CITY OF ST. HELENS PLANNING DEPARTMENT
STAFF REPORT
Conditional Use Permit CUP.2.23; Variances V.1.23, V.2.23, and V.3.23

DATE: March 14, 2023
TO: Planning Commission
FROM: Jacob A. Graichen, AICP, City Planner

APPLICANT: James Casey McGuirl of McGuirl Designs & Architecture
OWNER: La Grand Townhomes, LLC

ZONING: Mixed Use, MU and General Residential, R5
LOCATION: 4N1W-4AA-600; NW corner of Columbia Boulevard/N. 6th Street intersection; Lots 20-22, Block 60, St. Helens Subdivision
PROPOSAL: Mixed use development consisting of 9 dwelling units and up to three commercial suites, all within a single three-story building.

Figure D-41. Conceptual Streetscape Design for the Houlton/Riverfront District Corridor Segment - SUBJECT TO CHANGE

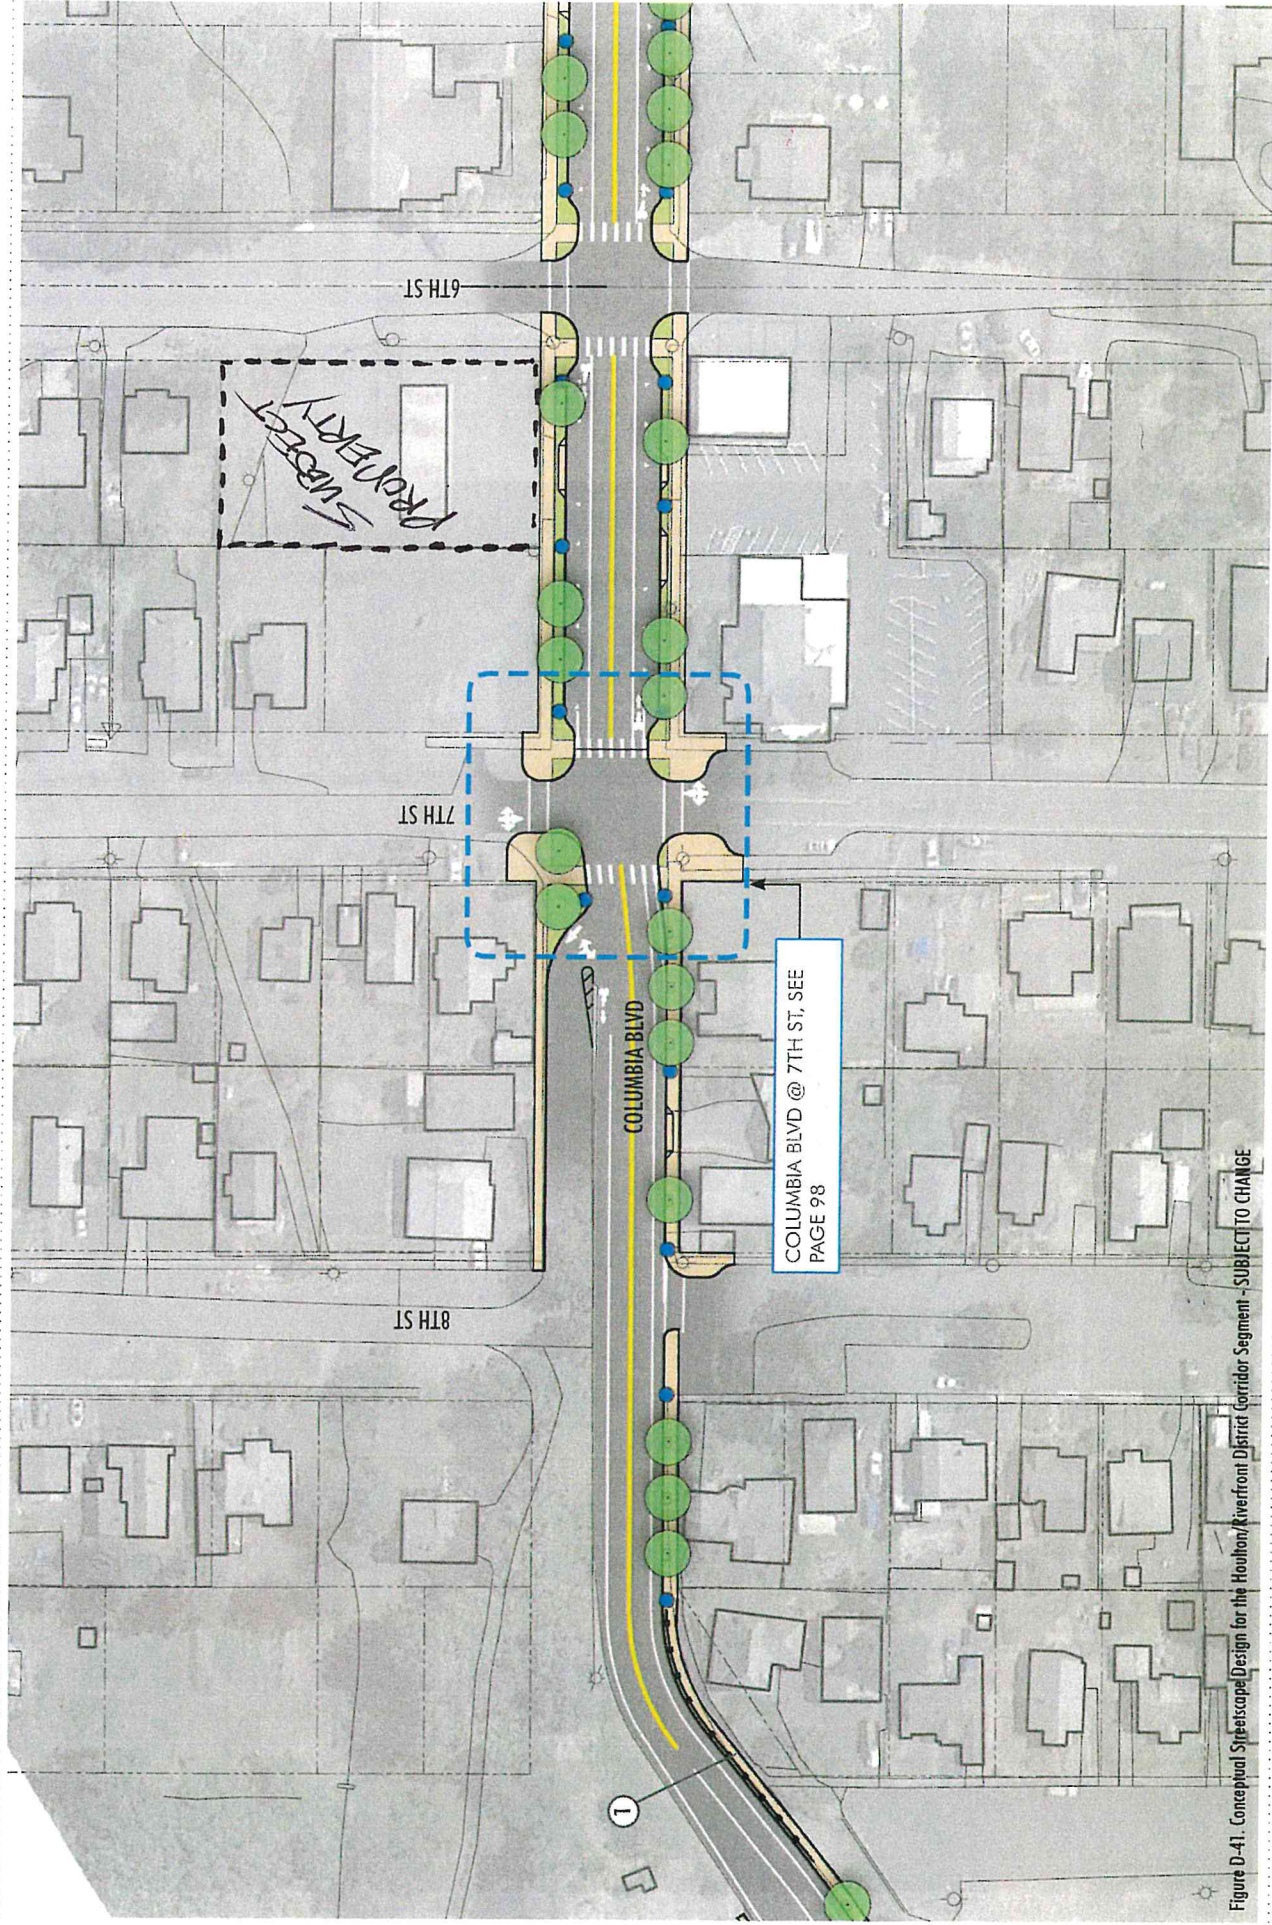
However, for Columbia Boulevard the 2015 Corridor Plan standards supersedes other standards and shows on-street parking (**see attached Corridor Plan Fig. D-41**). Probably no more than
